PHASE 2 RECYCLED WATER PUMP STATION

PREPARED FOR
TOWN OF BENNETT

60% DRAWINGS

COVER SHEET AND NOTES

FLOOR PLAN

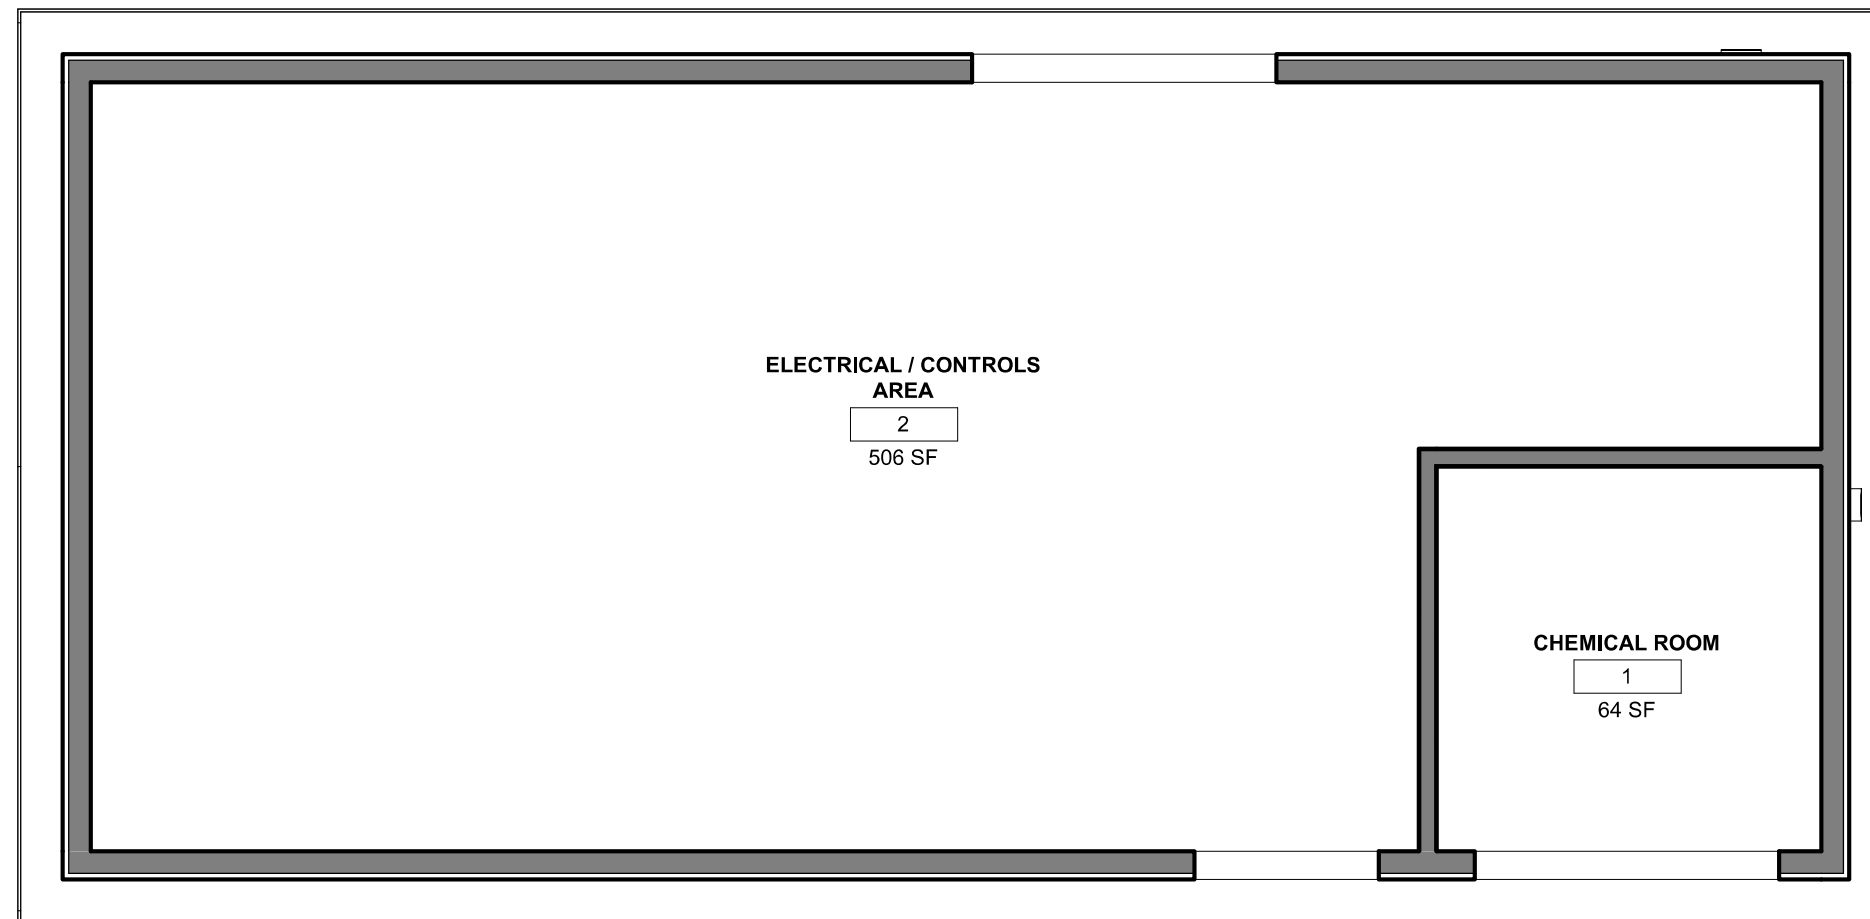
NOTE TO BIDDERS:
THE BUILDING SIZE WILL BE
38'x18' OUTSIDE
DIMENSIONS. REVISED
DRAWINGS TO BE ISSUED
VIA ADDENDA.

BUILDING
ELEVATIONS

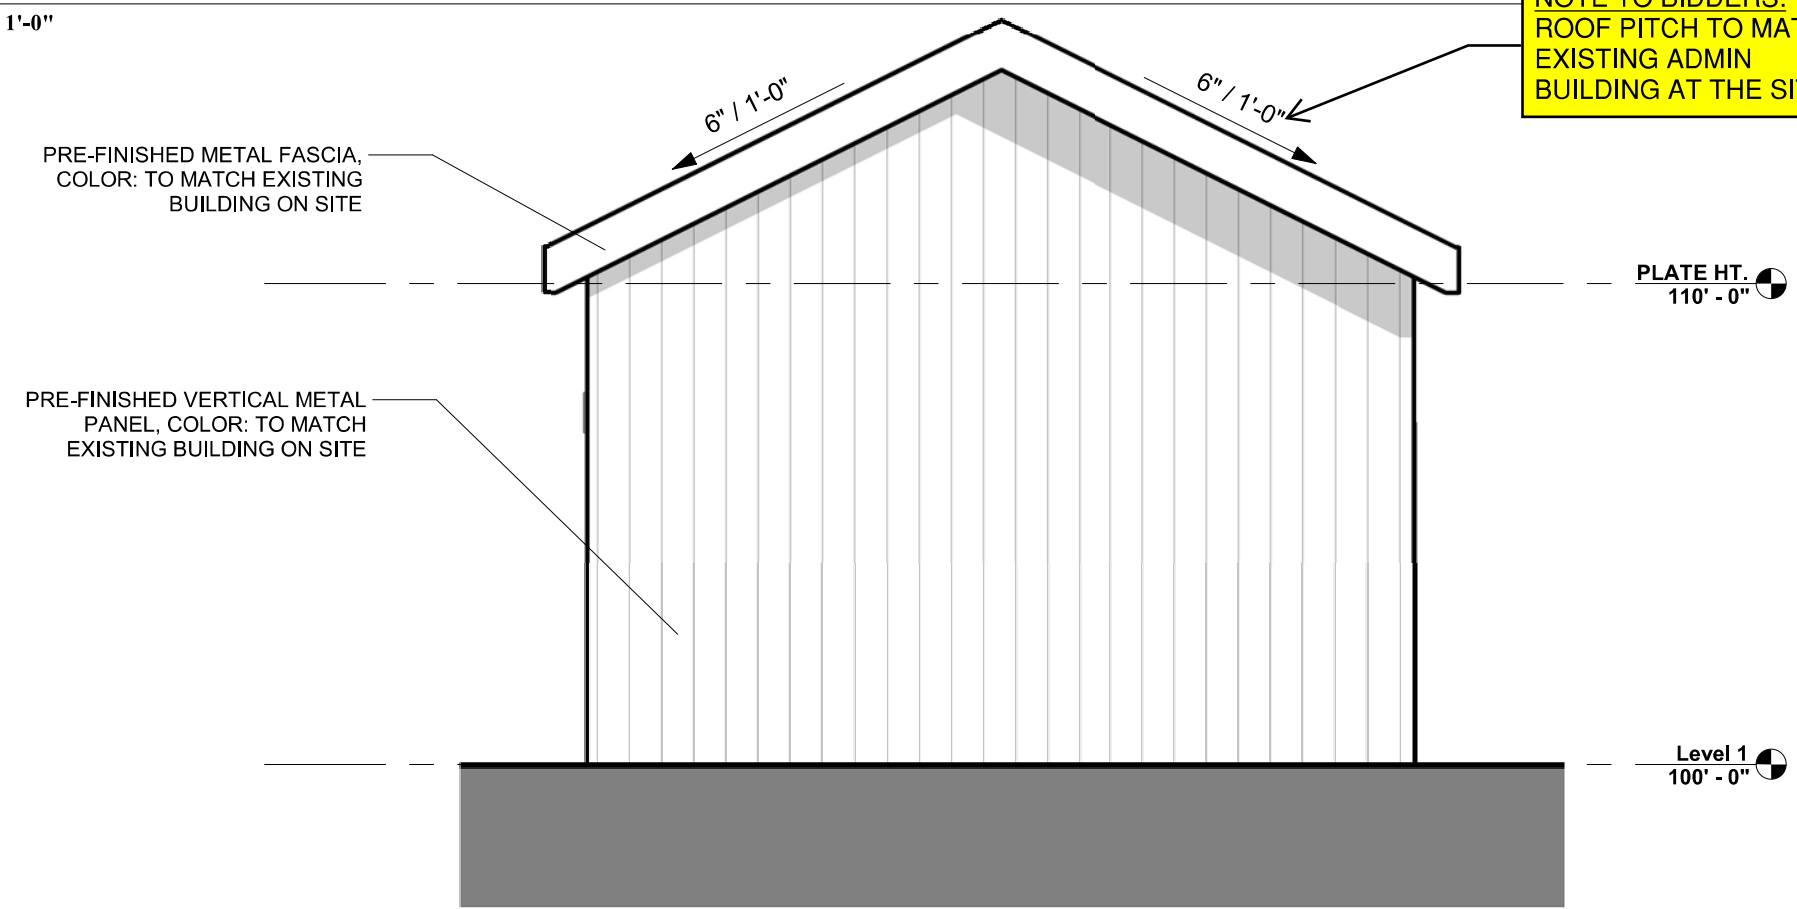
NOTE TO BIDDERS:
ROOF PITCH TO MATCH
EXISTING ADMIN
BUILDING AT THE SITE.

1
S3 ROOF FRAMING PLAN

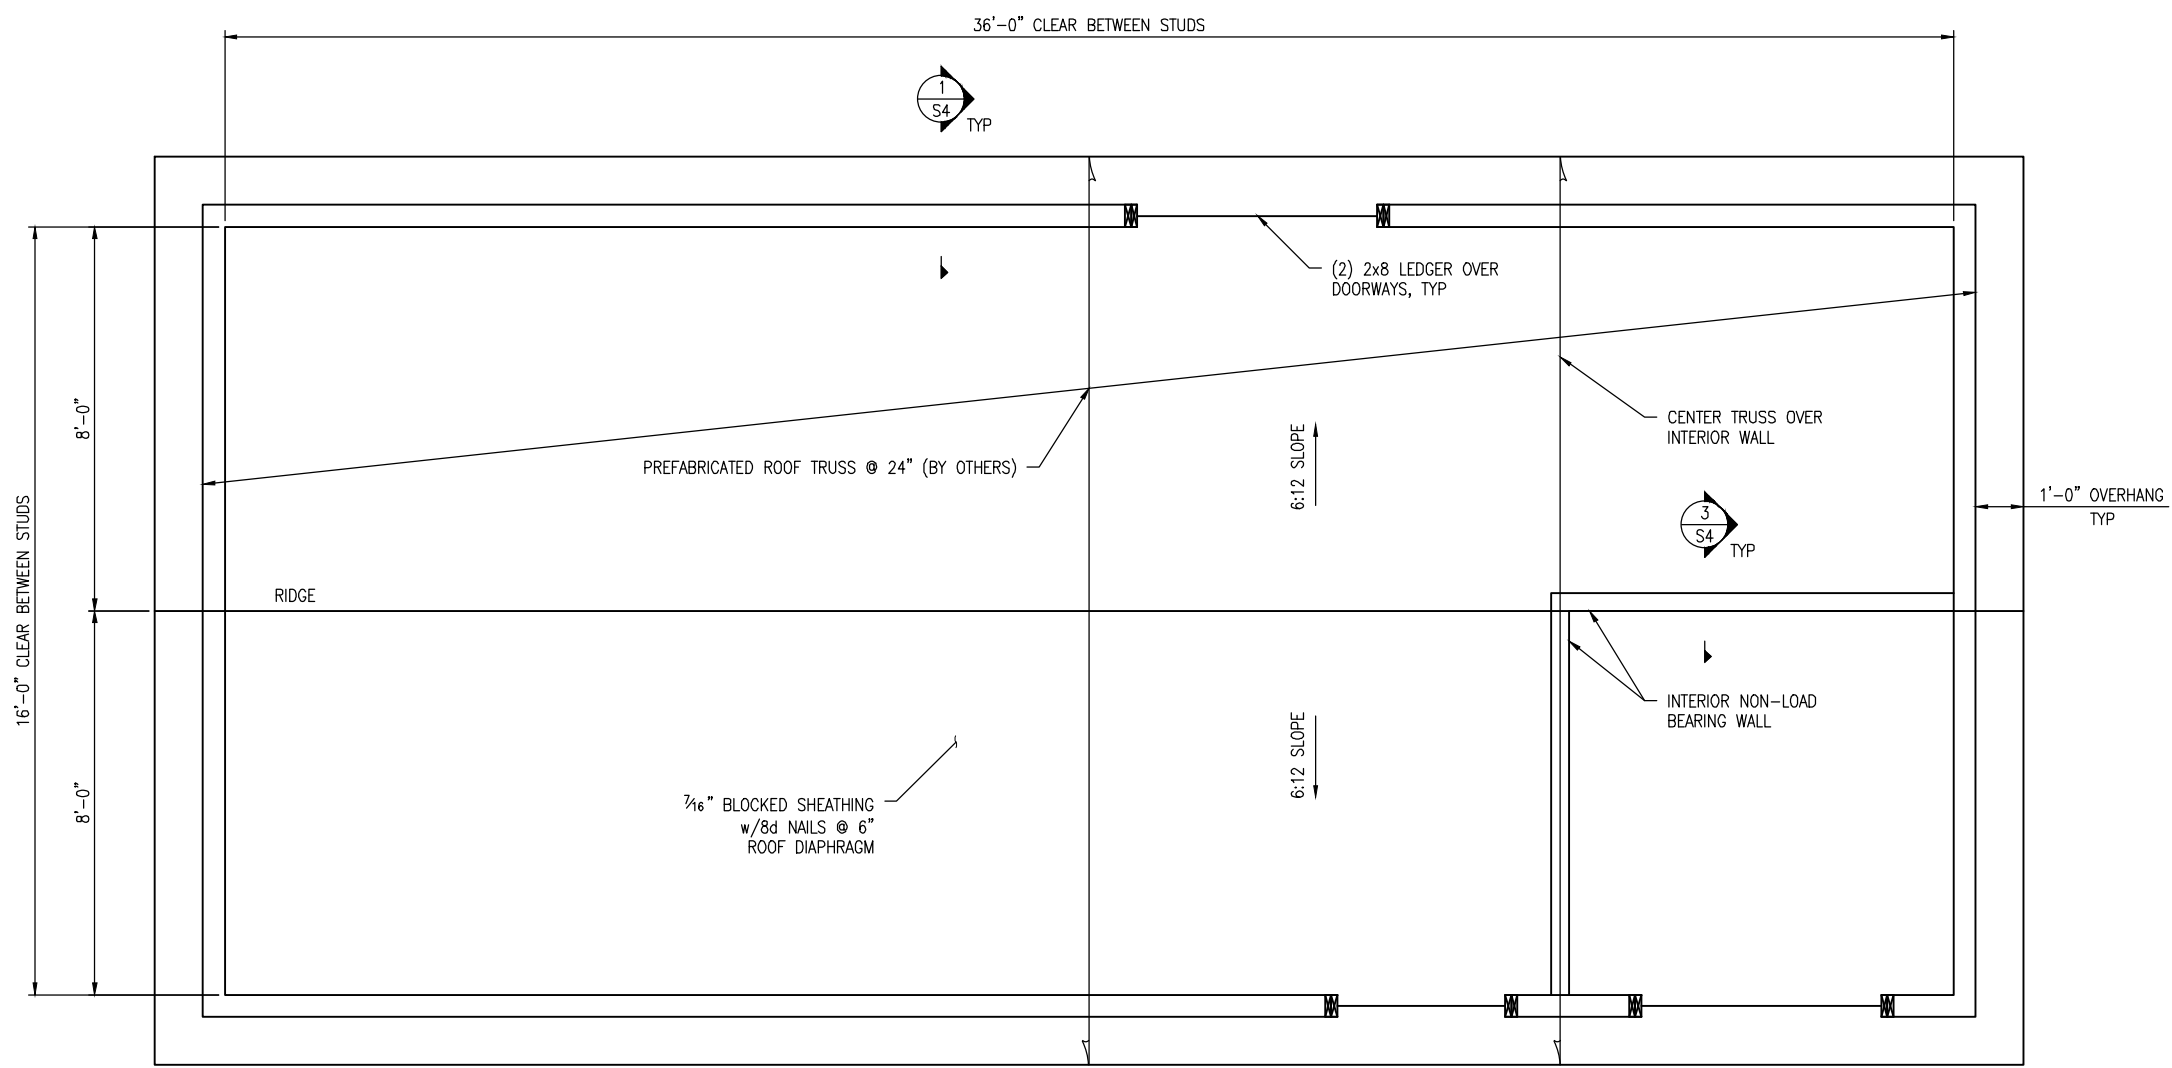
NOTE TO BIDDERS:
THE BUILDING SIZE WILL BE
38'x18' OUTSIDE
DIMENSIONS. REVISED
DRAWINGS TO BE ISSUED
VIA ADDENDA.

1
S4 TYPICAL EAVE DETAIL

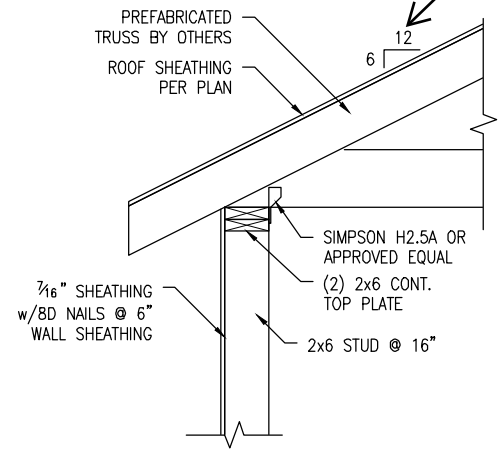
**NOTE TO BIDDERS:
ROOF PITCH TO MATCH
EXISTING ADMIN
BUILDING AT THE SITE.**

PIPING SECTION VIEWS

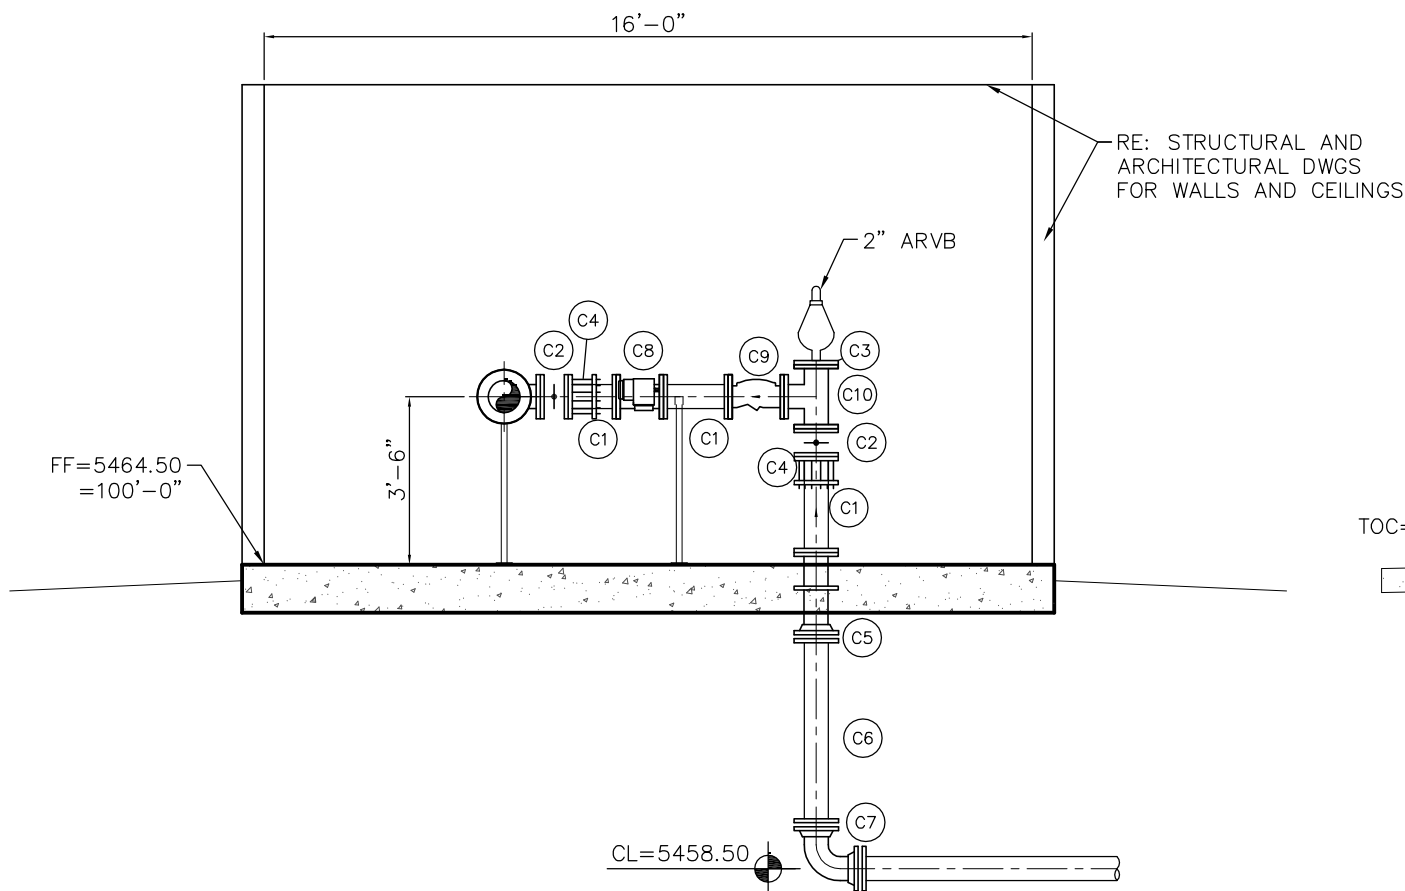
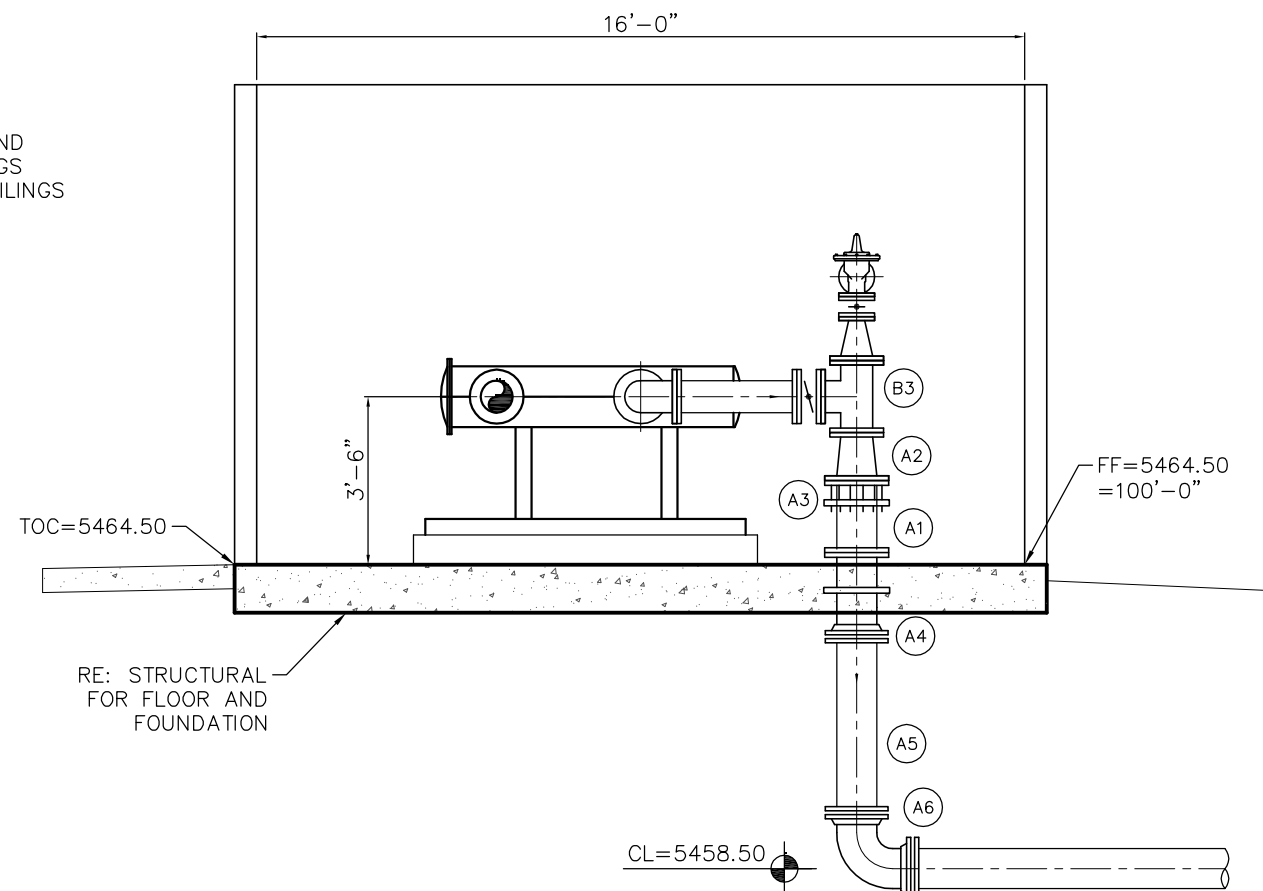
NOTE TO BIDDERS:
THE BUILDING SIZE WILL BE 38'x18' OUTSIDE DIMENSIONS. REVISED DRAWINGS TO BE ISSUED VIA ADDENDA.

BUILDING PLAN
VIEW

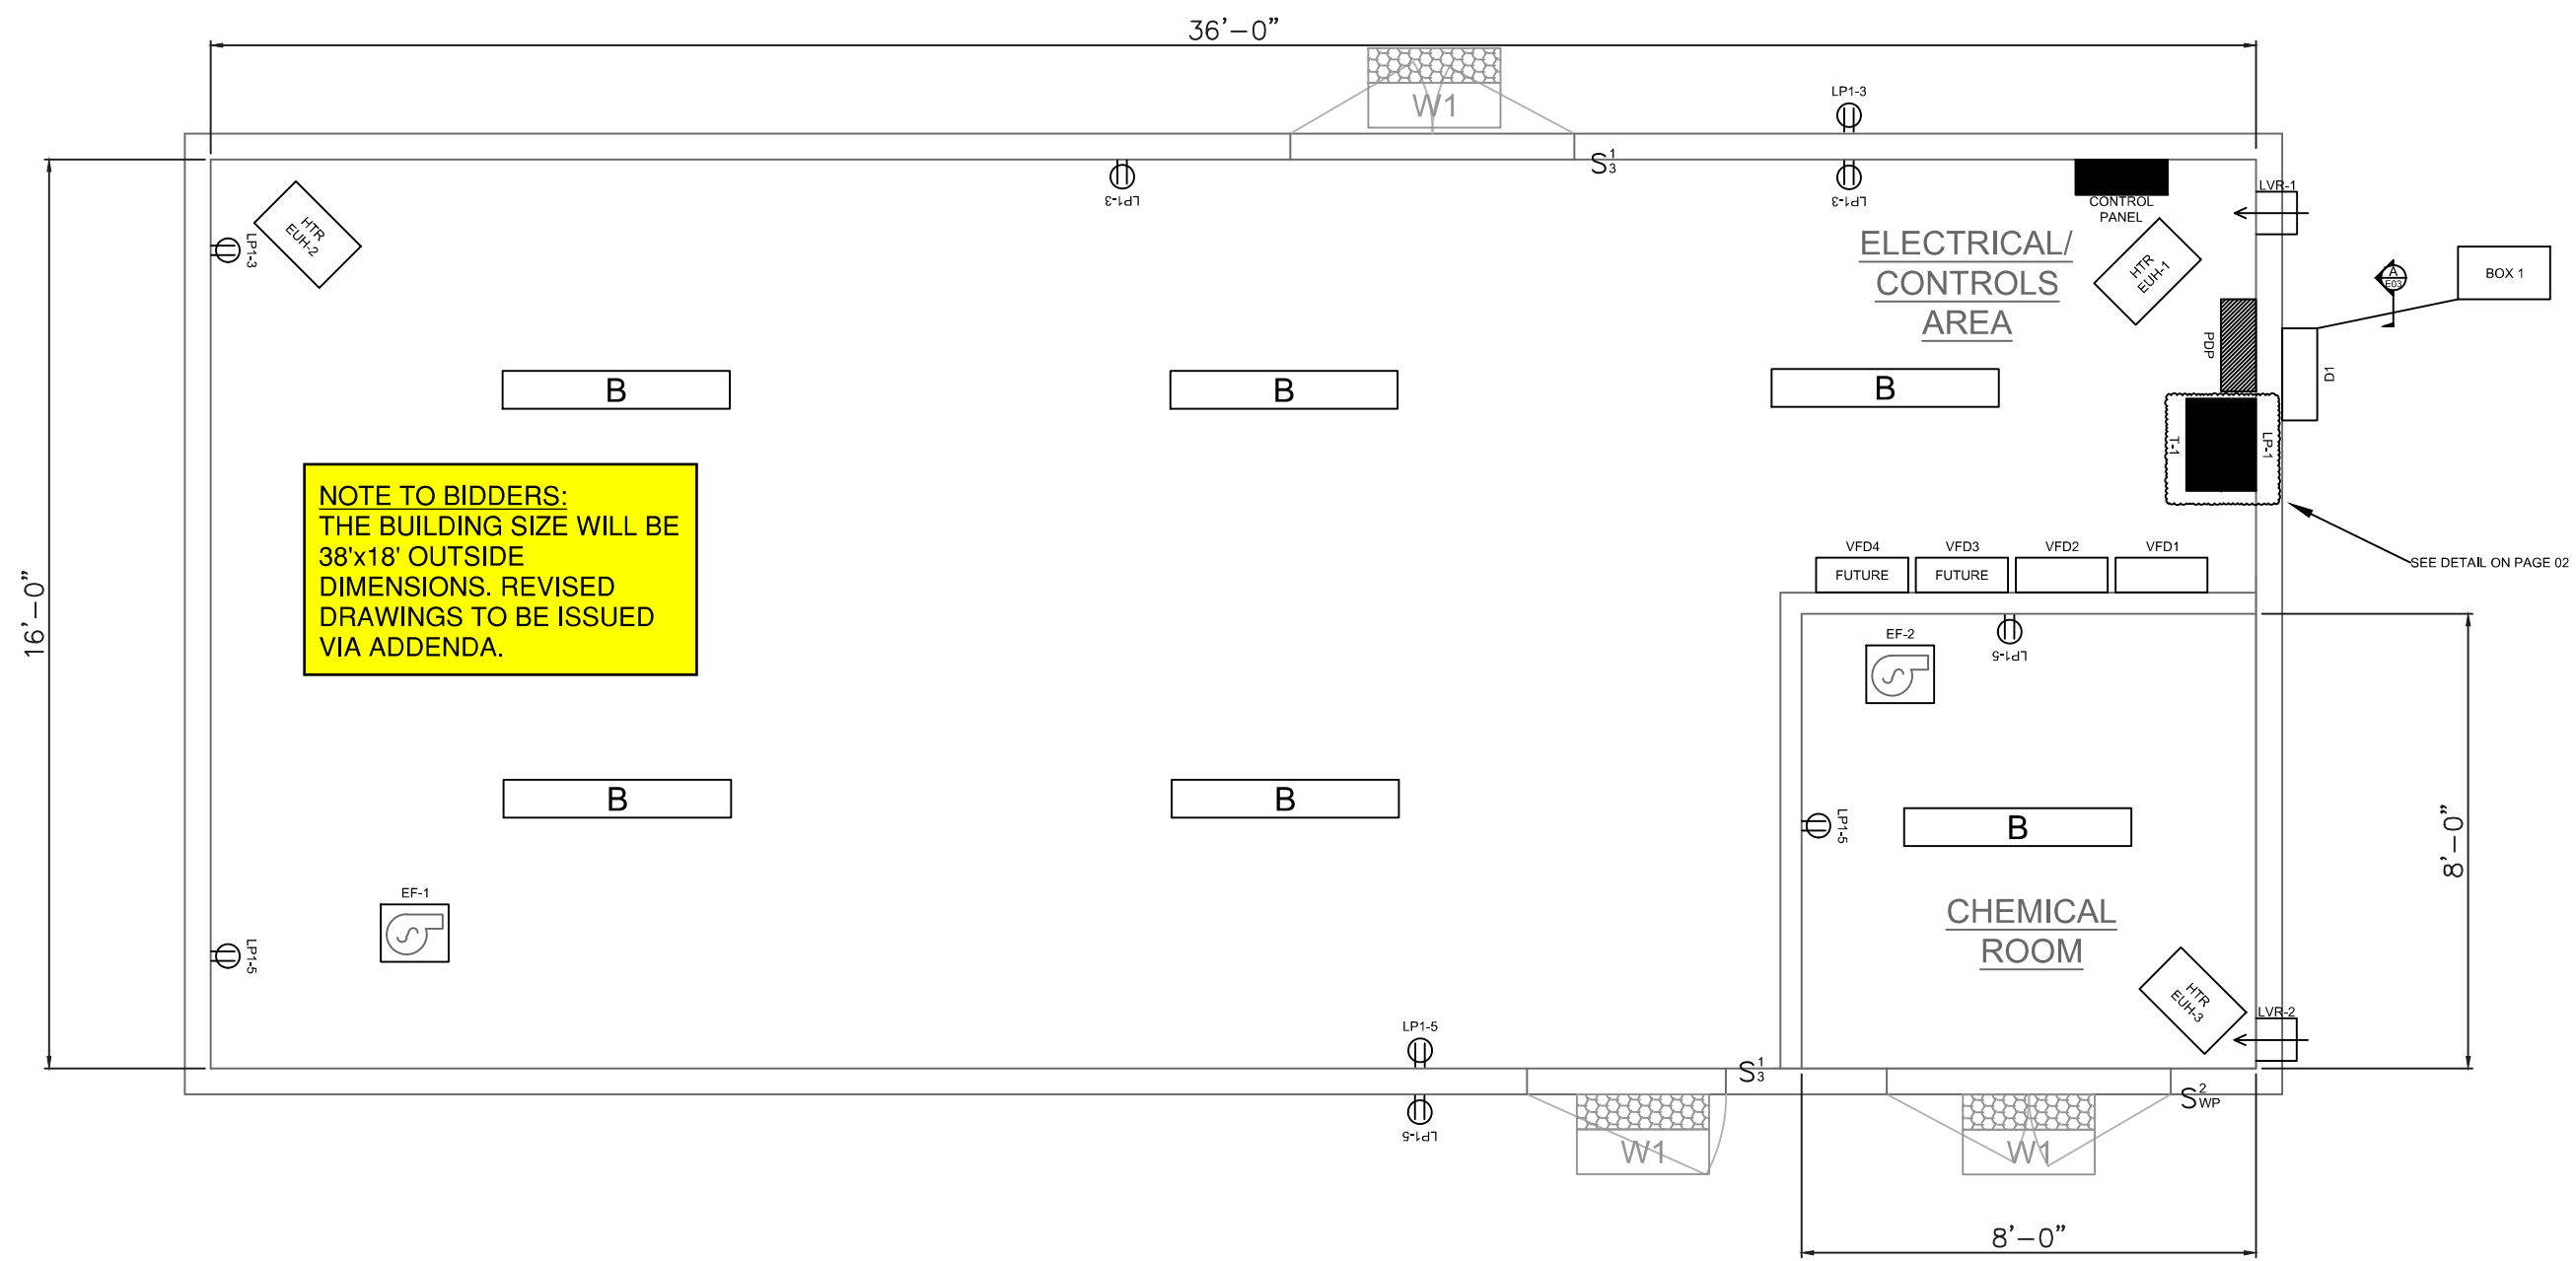
NOTE TO BIDDERS:
THE BUILDING SIZE WILL BE 38'x18' OUTSIDE DIMENSIONS. REVISED DRAWINGS TO BE ISSUED VIA ADDENDA.
